City of Plymouth Planning Commission Special Meeting Agenda Wednesday, October 27, 2021 – 7:00 p.m. ONLINE Zoom Webinar

**Site Plan Review
For
Plymouth, Michigan**

Subject: Response to Review Comments
Plan Review
1115 S. Main Street
6/25/2021

RE: E.G. Nicks – Revised Site Plan Materials

Sheet Name
Elevations

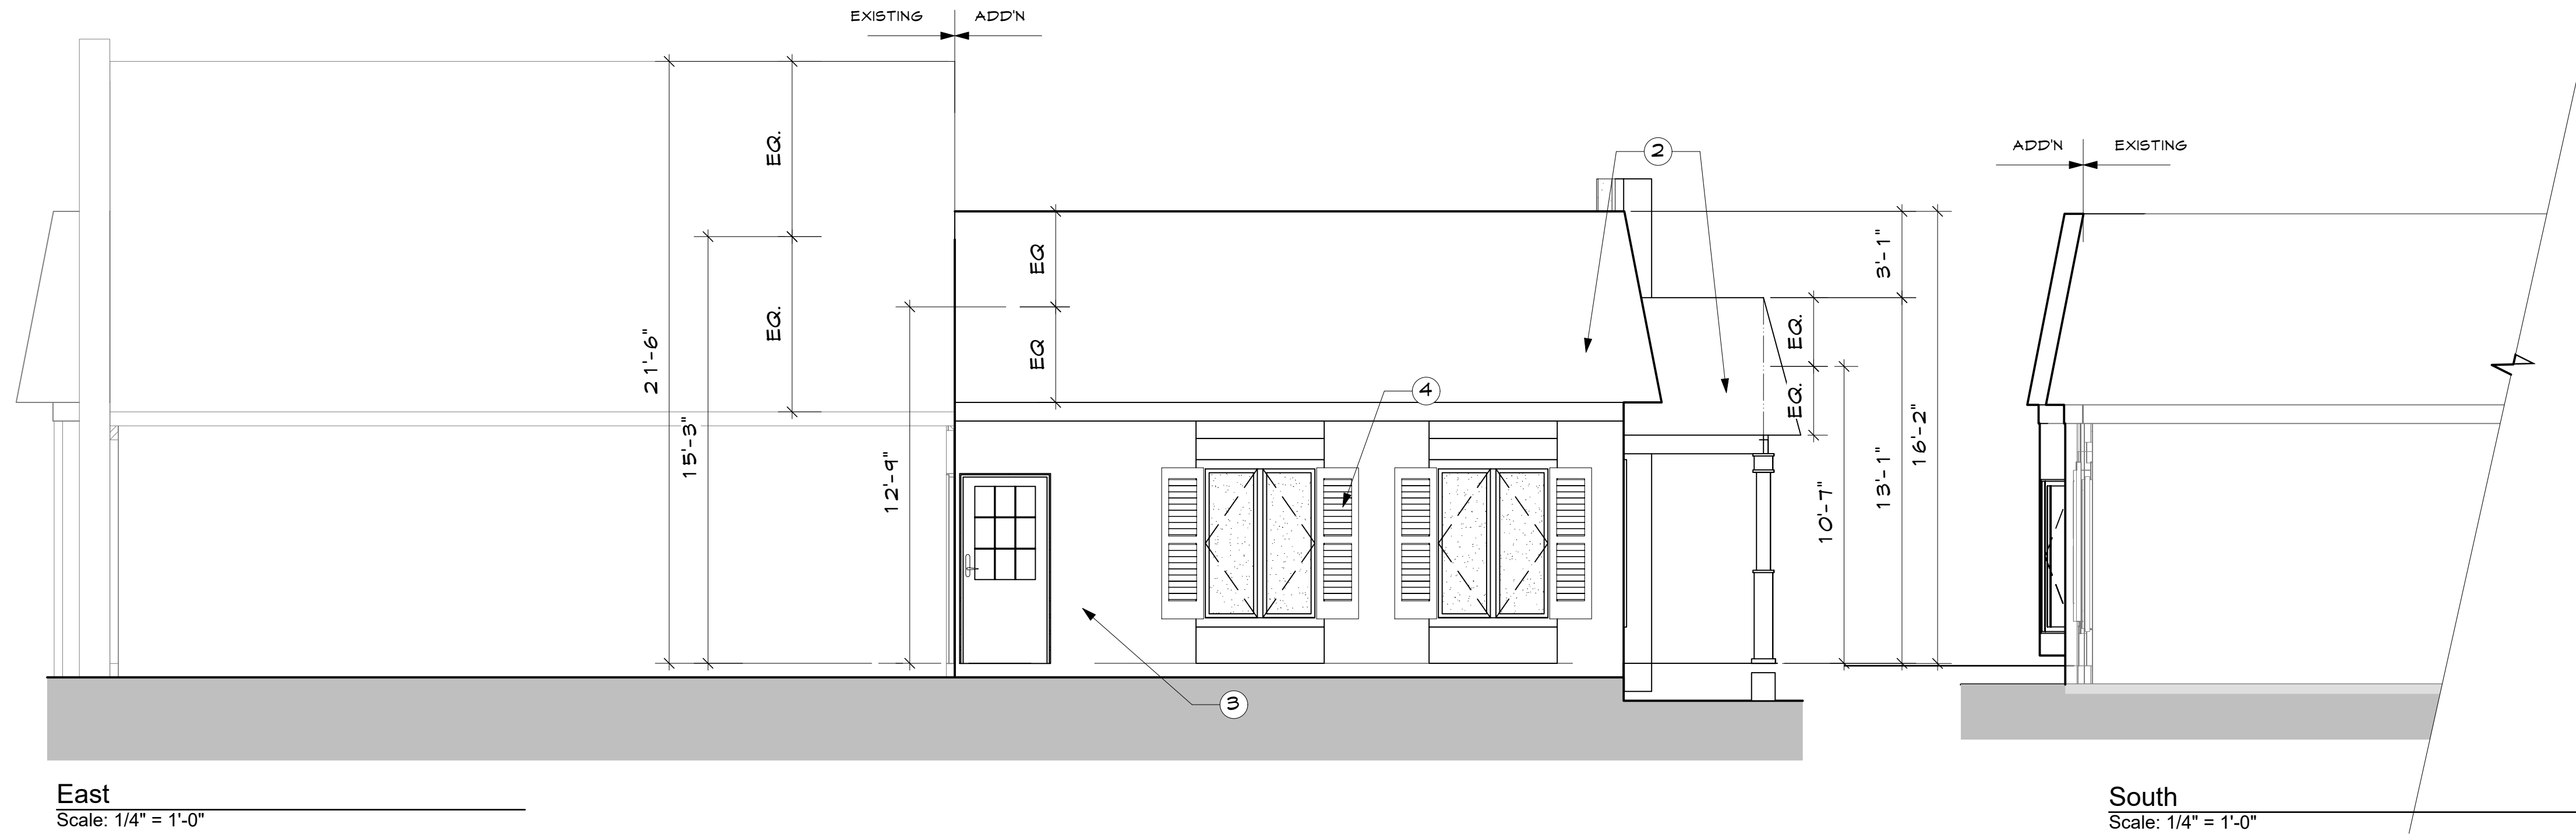
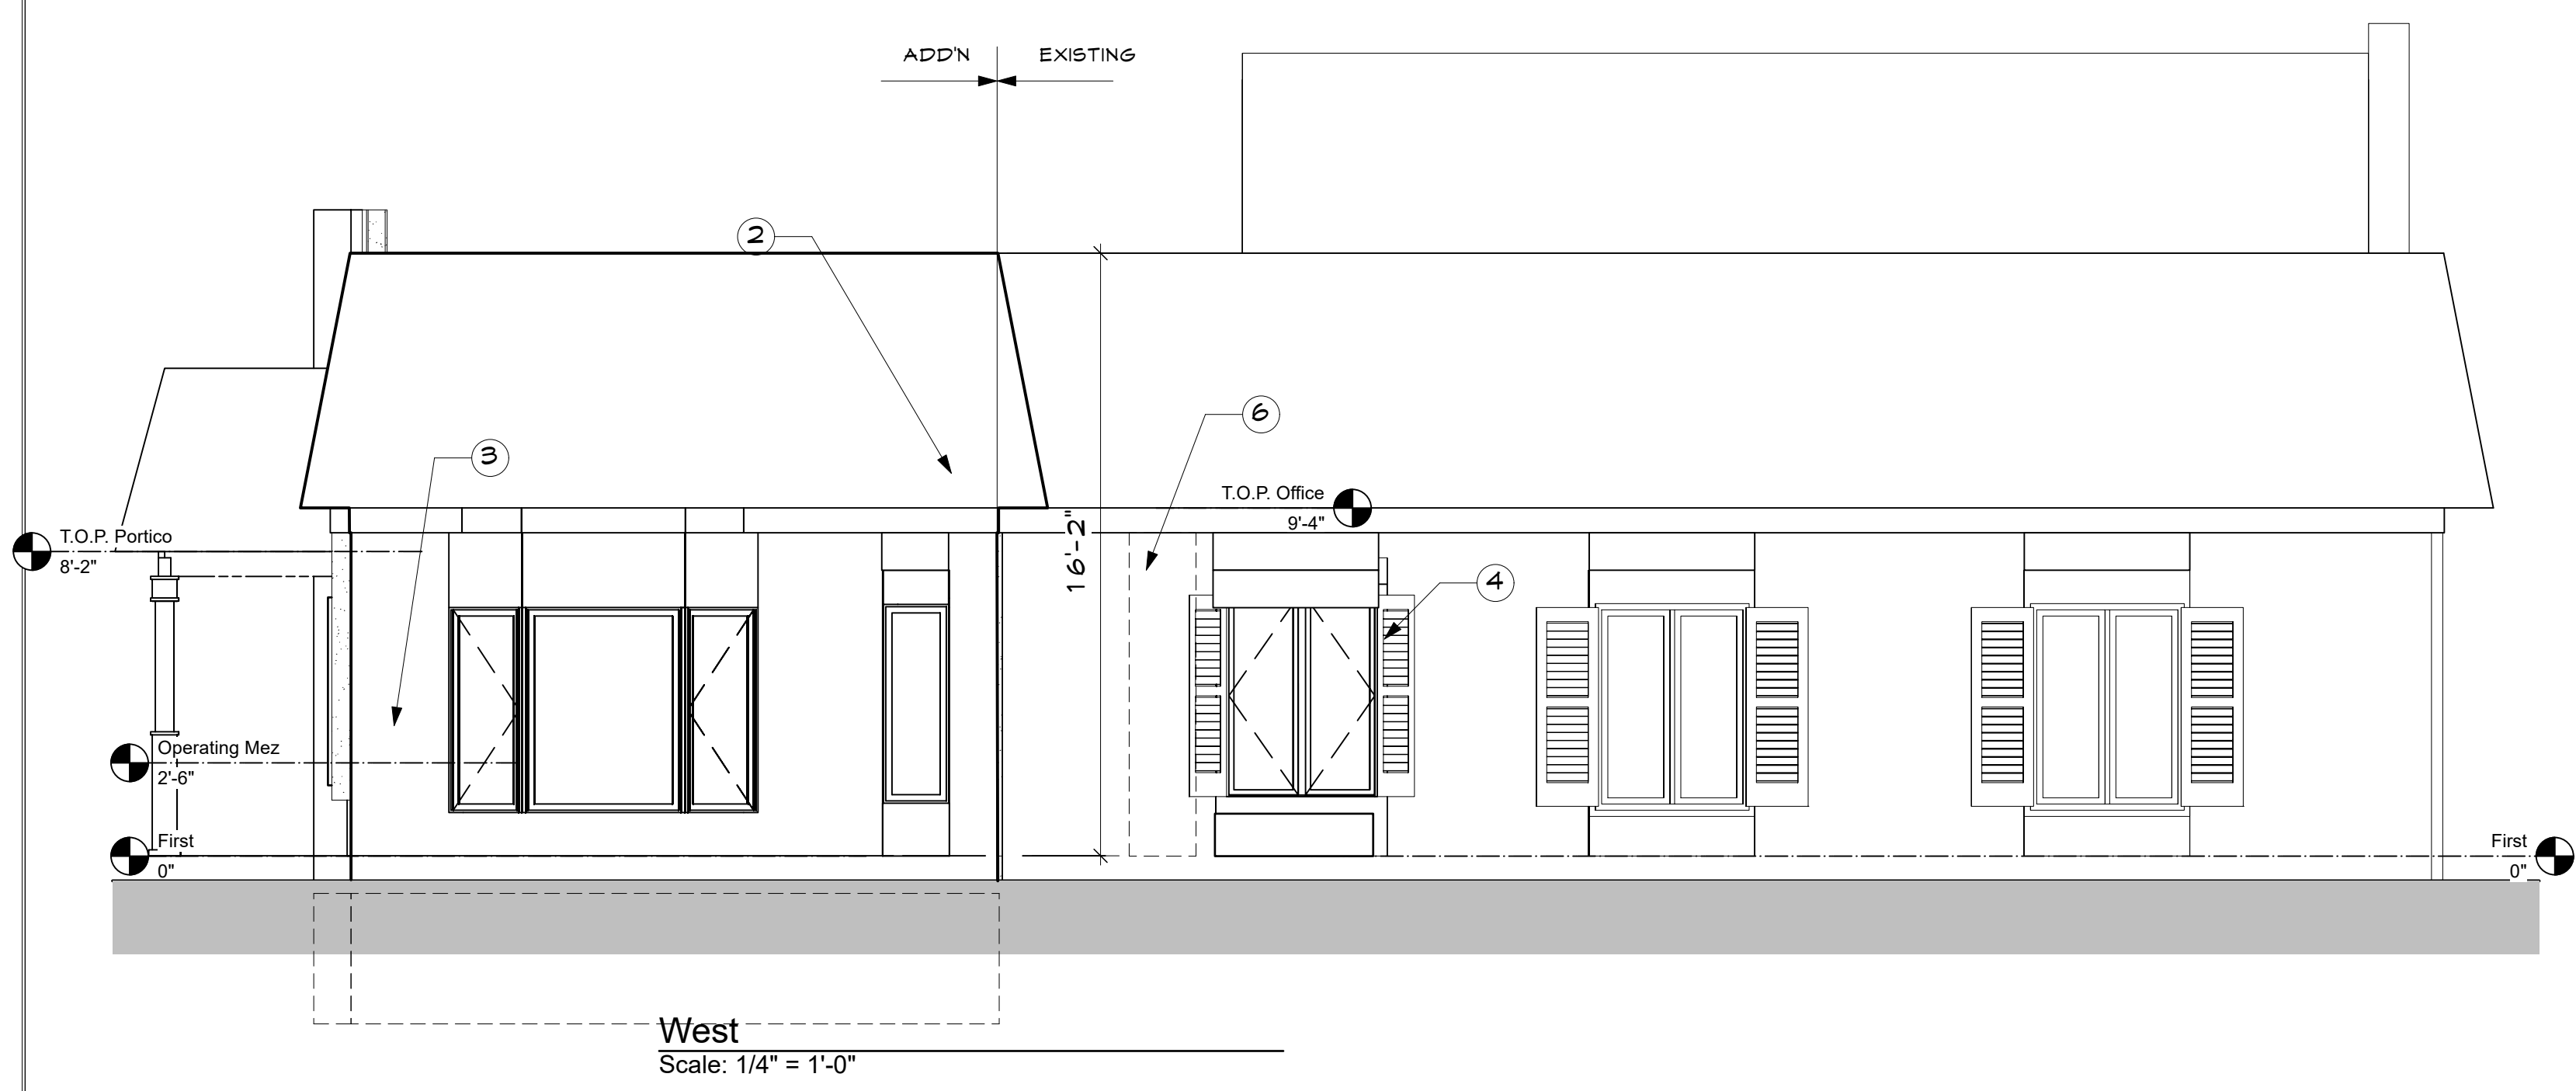
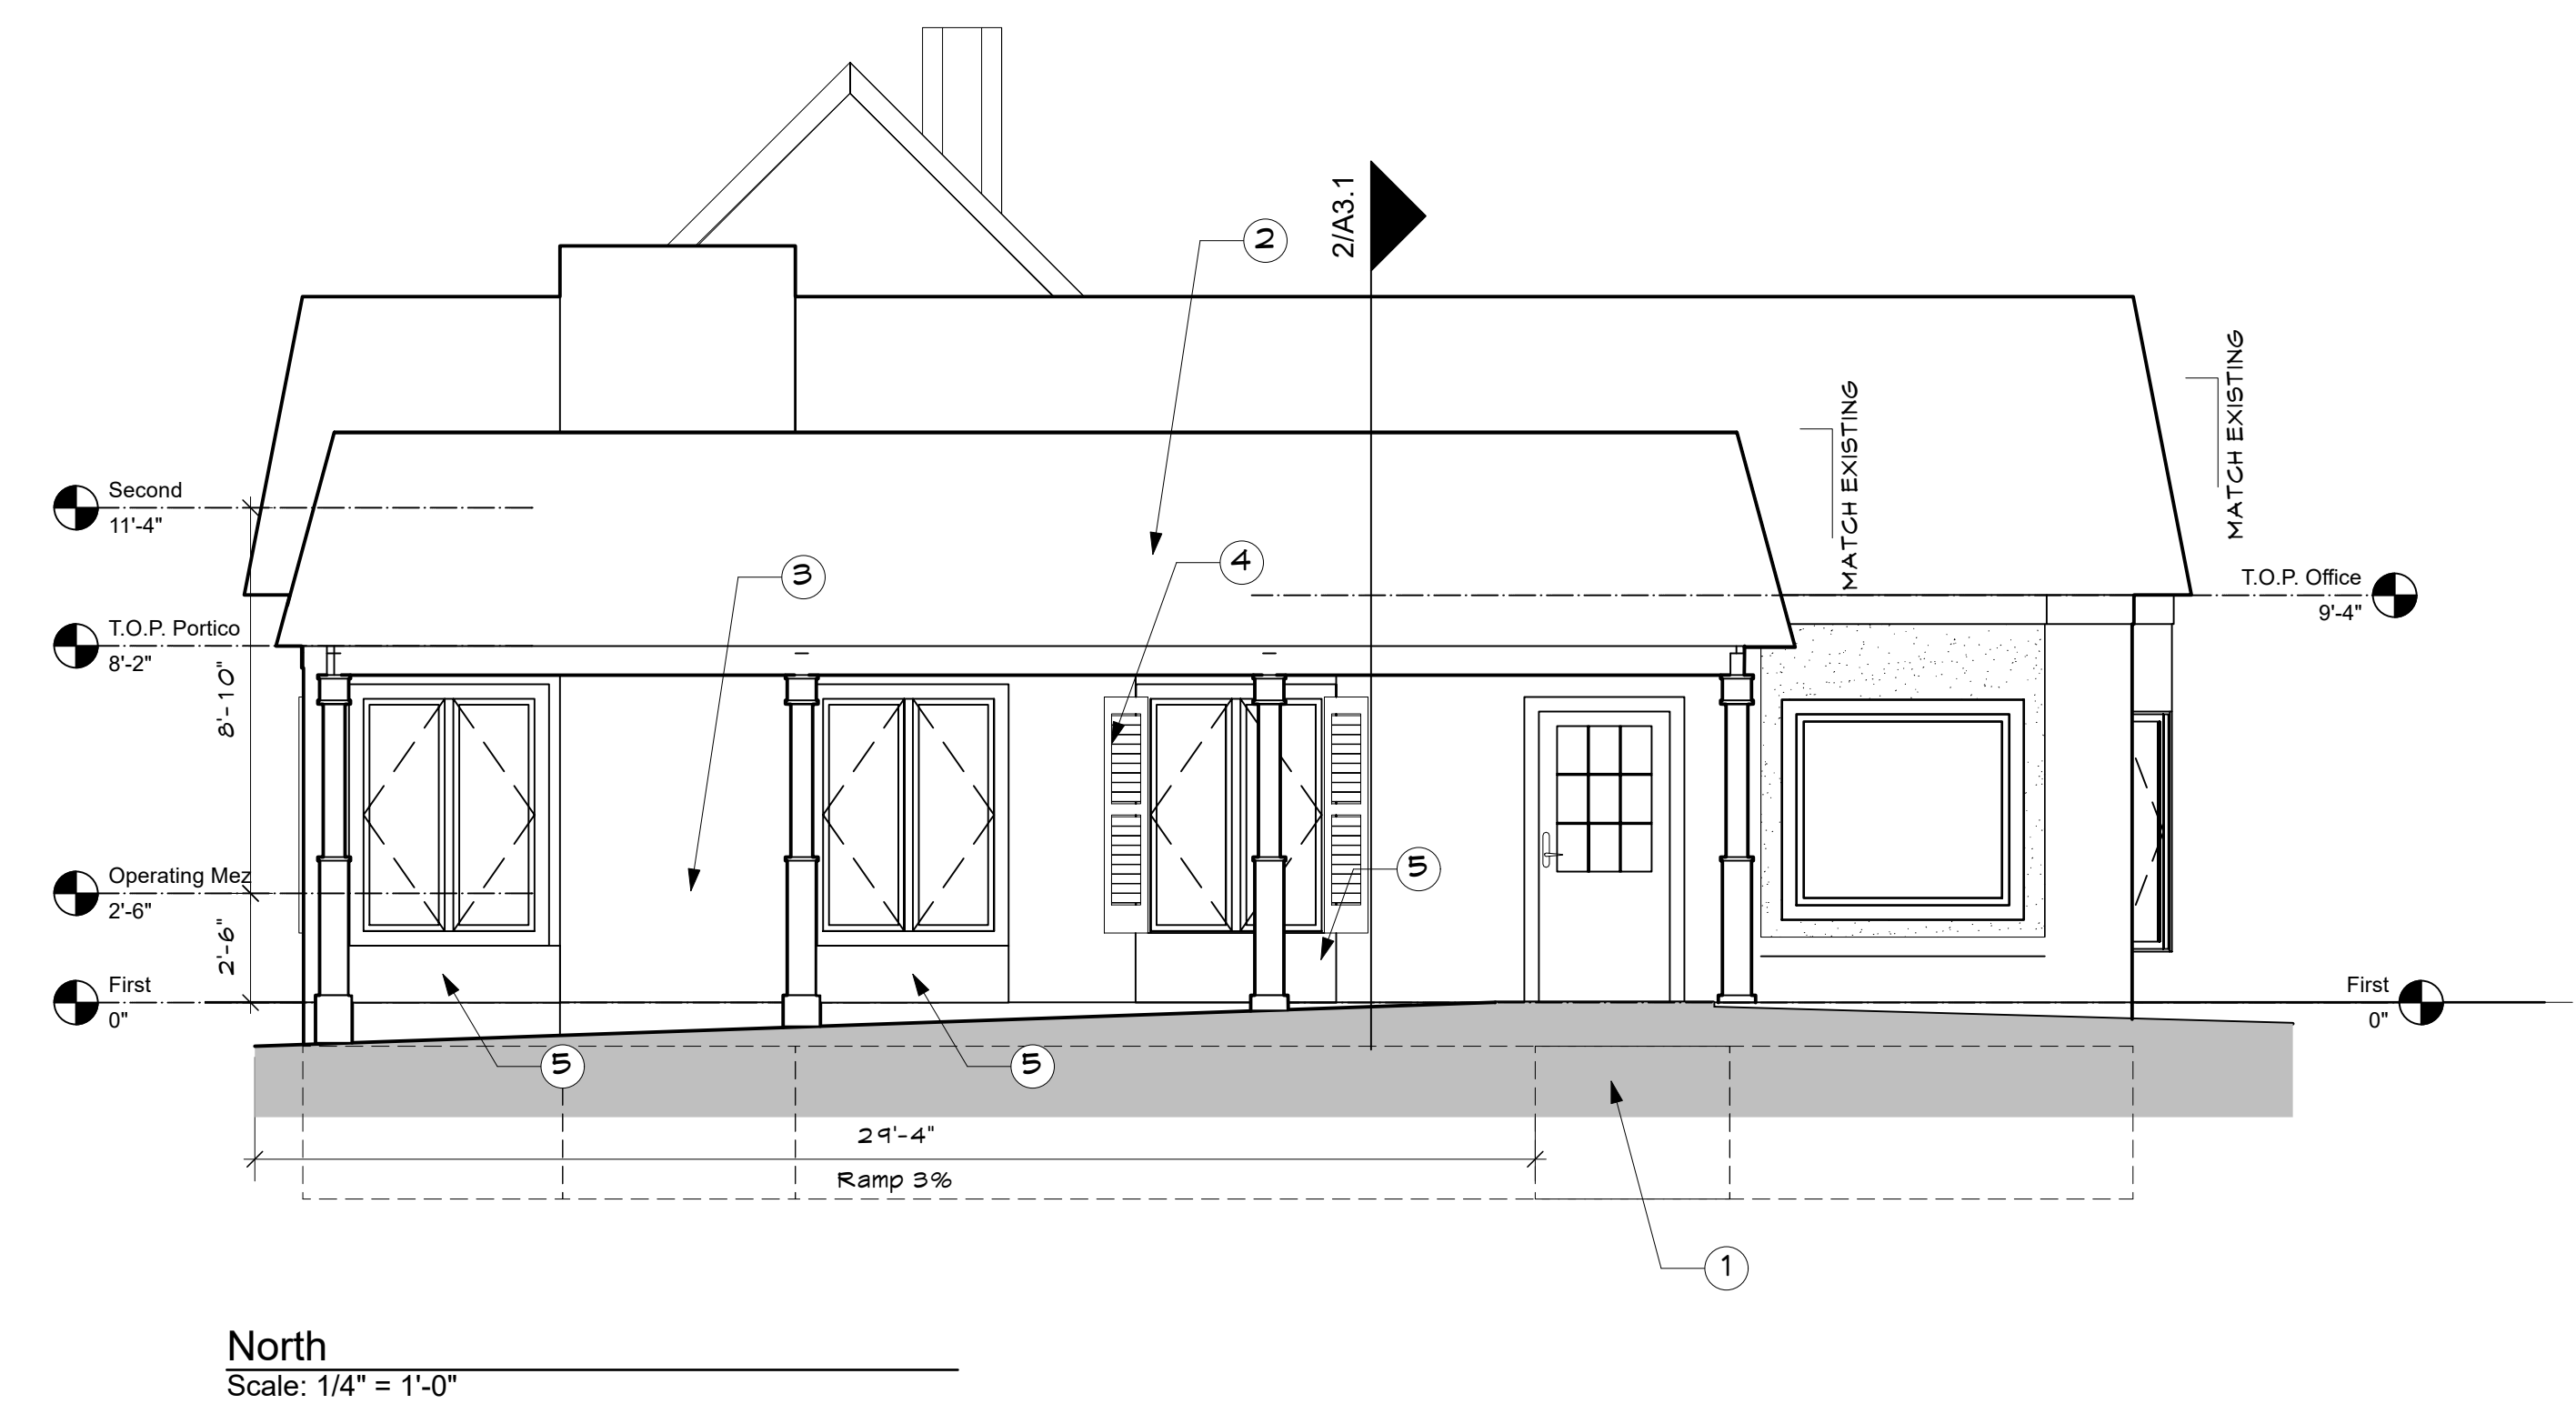
2. *Area, Width, Height, Setbacks. Show proposed height of the new addition on the site plan as defined by the ordinance.*

Dimensions have been added to the Elevation Sheet A2.1 showing the height of the existing structure and proposed addition.
